Re: **Abrazo Homes LLC/Santa Monica Estates; CGP; SIC 1521; NPDES Compliance Evaluation Inspection; NPDES # NMR10009D; December 20, 2017**

NPDES Construction General Permit Inspection Report – State of New Mexico

NMED/SWQB Official Photograph Log Photo # 2		
Photographer: Jennifer Foote	Date: 12/20/17	Time: 1:35 pm
City/County: Albuquerque, Bernalillo		State: New Mexico
Location: Santa Monica Estates		
Subject: Abrazo/TQM SWPPP site map showing parcel ownership for the three owners.

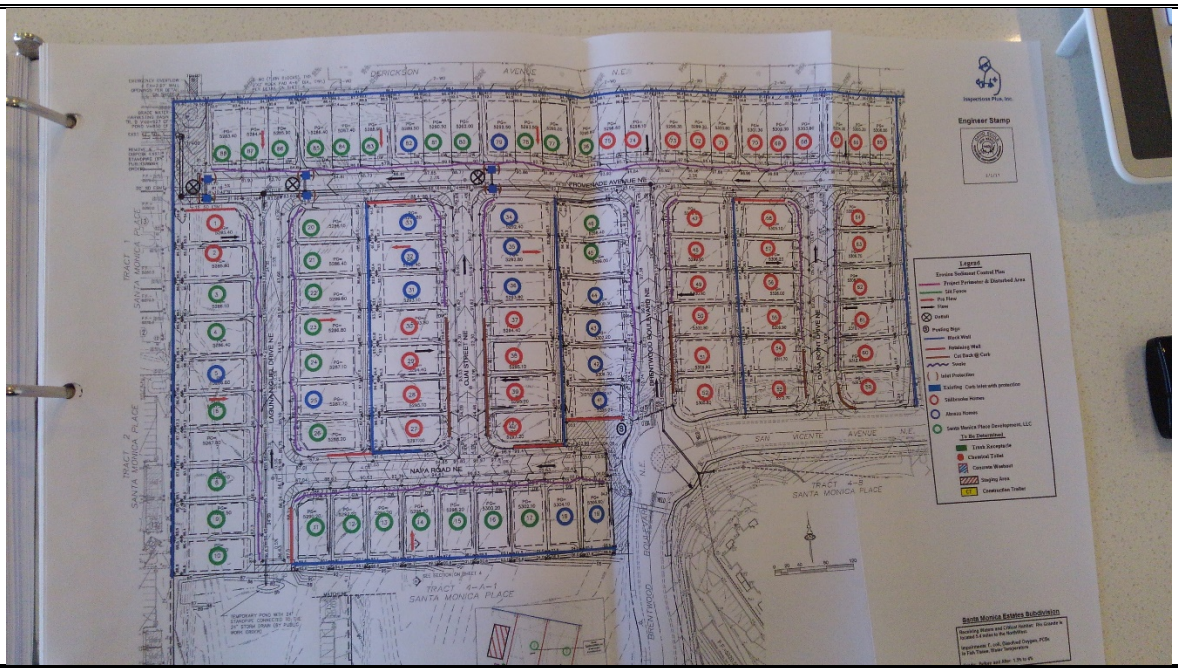
SWPPP:
A SWPPP for Abrazo and TQM for Santa Monica Estates Subdivision certified March 2017 was available at the sales office onsite, but it did not contain updated maps or completed inspections. Inspections were sent by email later that day.

- Part 7.1 The SWPPPs for Abrazo Homes/TQM and Santa Monica Place Development LLC including dates of disturbance, site maps, and BMP installation tables were not updated with actual locations and types of pollutants.
- Part 7.2 Stillbrooke Homes did not provide a SWPPP.
